**DETAILED RESPONSE TO REGULATORY COMMENTS ON DRAFT EA REPORT  
(VERSION 2)**

**Subject: Combined Responses to Regulatory Comments on Groundwater-related Topics, Rainy River Project Draft Environmental Assessment Report**

Combined Responses to Regulatory Comments on Groundwater-related Topics

**Potentiometric lines for (a) 1500 and (b) 3000 metres below sea level models**

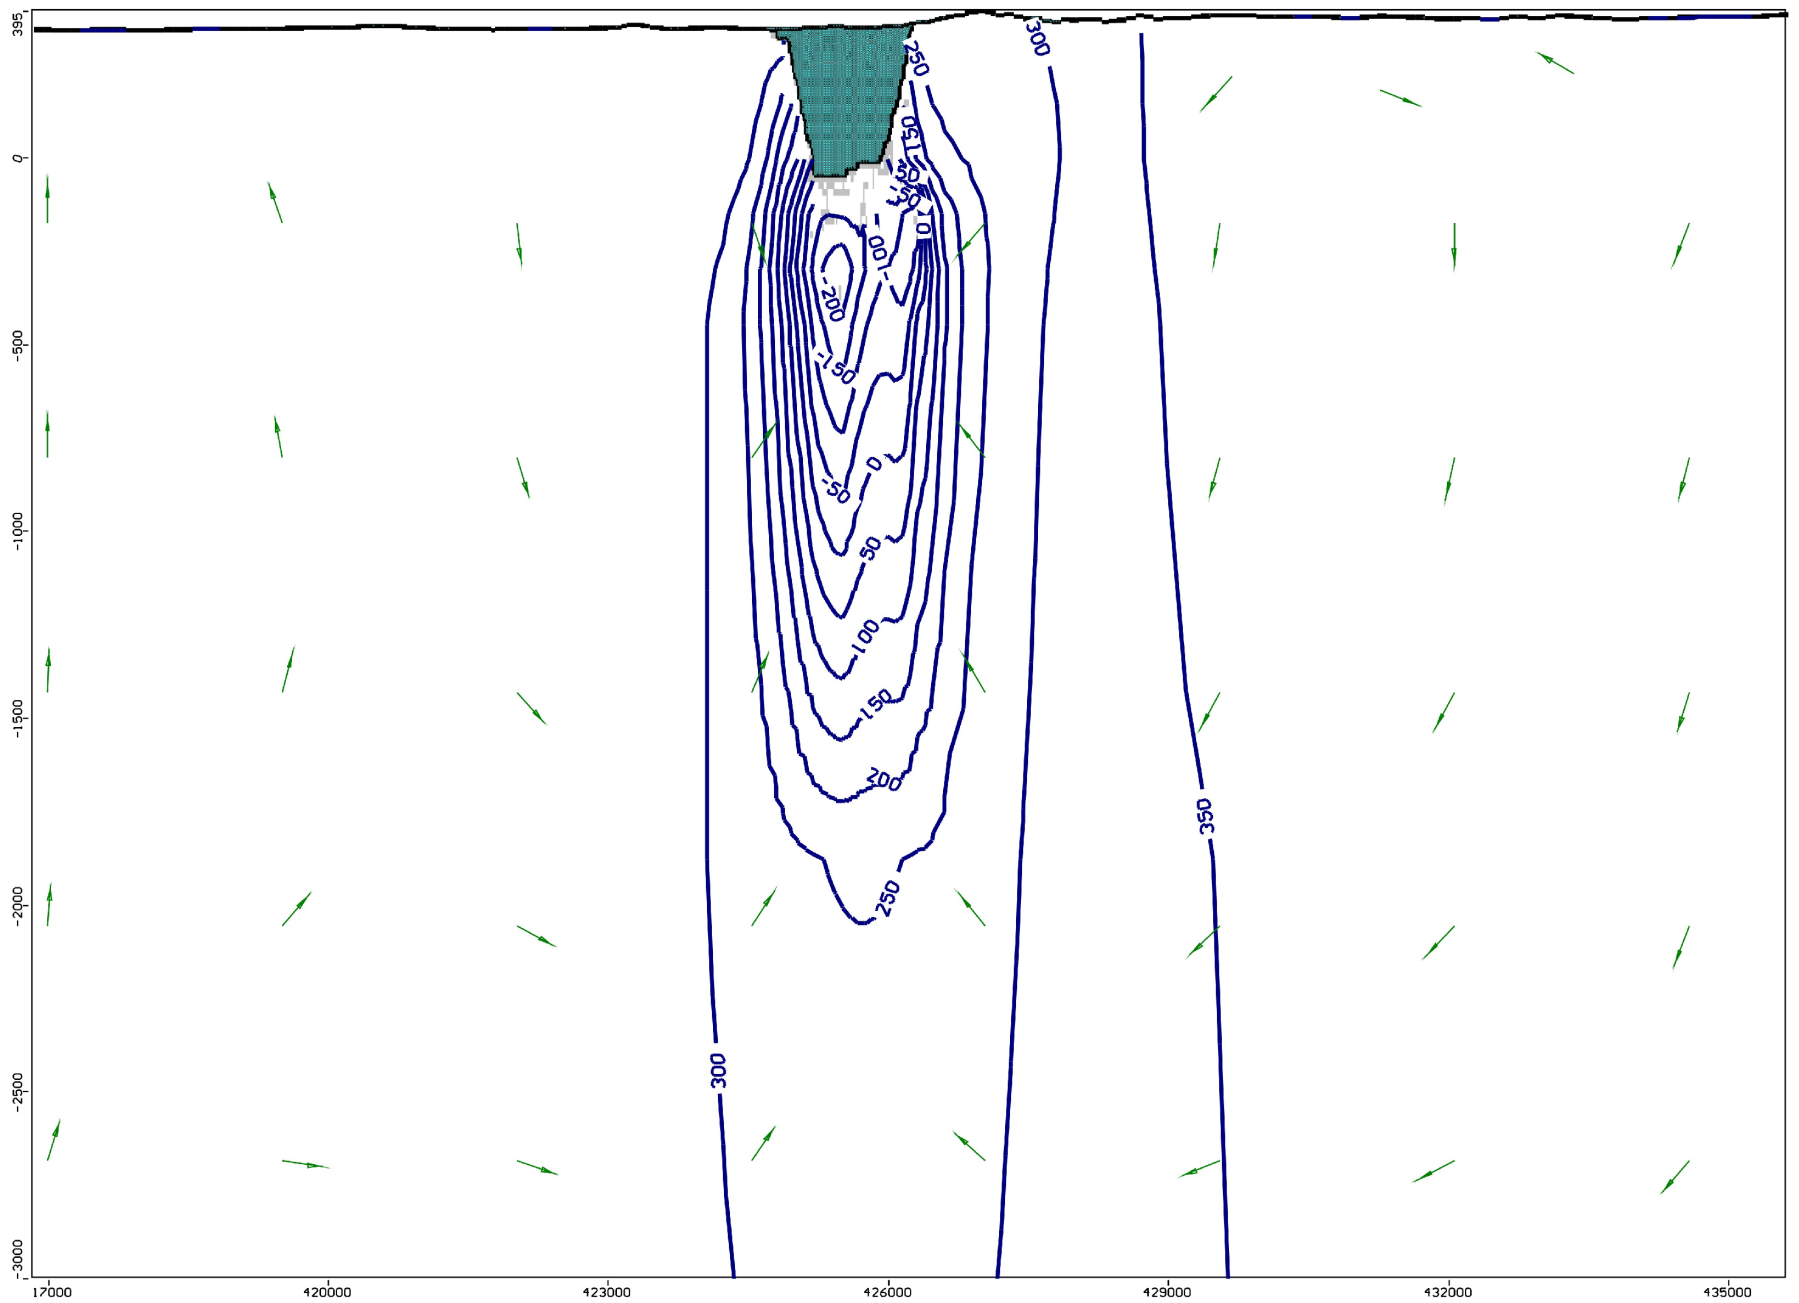
The hydrogeological model domain needs to be extended to reduce potential boundary effects. Significant changes in head are observed at the bottom boundary of the model domain (Appendix S, Figure 3-2) and it is believed that these changes could introduce inconsistencies in the simulated results. An extension of the model domain, or justification as to why it is not necessary, is needed.

For the final EA, the size of the model domain should be increased to a size which yields no changes in head at the bottom boundary or the size of the model domain must be more thoroughly justified with respect to model accuracy.

*Response to Comment 4 (pertaining to the results shown in Figure 3-2 and model predicted inflows):* *In order to examine the impact of the model bottom boundary on the predicted results the bottom of the model was lowered from -1,500 to -3,000 metres above sea level (masl) and two additional model layers were added below the elevation of -1,500 masl. As a result, less noticeable changes in heads at the bottom boundary were computed: maximum computed drawdown in the lowest / deepest model layer was reduced from about 200 to 70 m (Figures 4a and 4b, respectively). Despite significant reduction in drawdown at the lowered model bottom, the model predicted groundwater seepage rate into the fully developed mine increased by about 70 m<sup>3</sup>/d, which constitutes only 2%, compared with the reported inflow rate of 3,400 m<sup>3</sup>/d. Lowering of the model bottom from -1,500 to -3,000 masl had also very little effect on the computed heads in shallow layers, including layers 5 (PLGD) and 6 (Shallow Bedrock). As a result, model predicted ZOI, defined by a 1 m drawdown contours in these layers, remained almost the same as the previously reported one (AMEC May 2013). Minor variations in model predicted seepage rate and ZOI, associated with the lowering of the model bottom are attributed to the low K-value (1E-9 m/s) assigned to the deep bedrock layers. Note that the changes introduced by the deepening of model bottom would have been even smaller if the hydraulic conductivity of the deepened portion (below -1,500 masl) was assumed to be less the bedrock K-value above, i.e., less than 1E-9 m/s.*
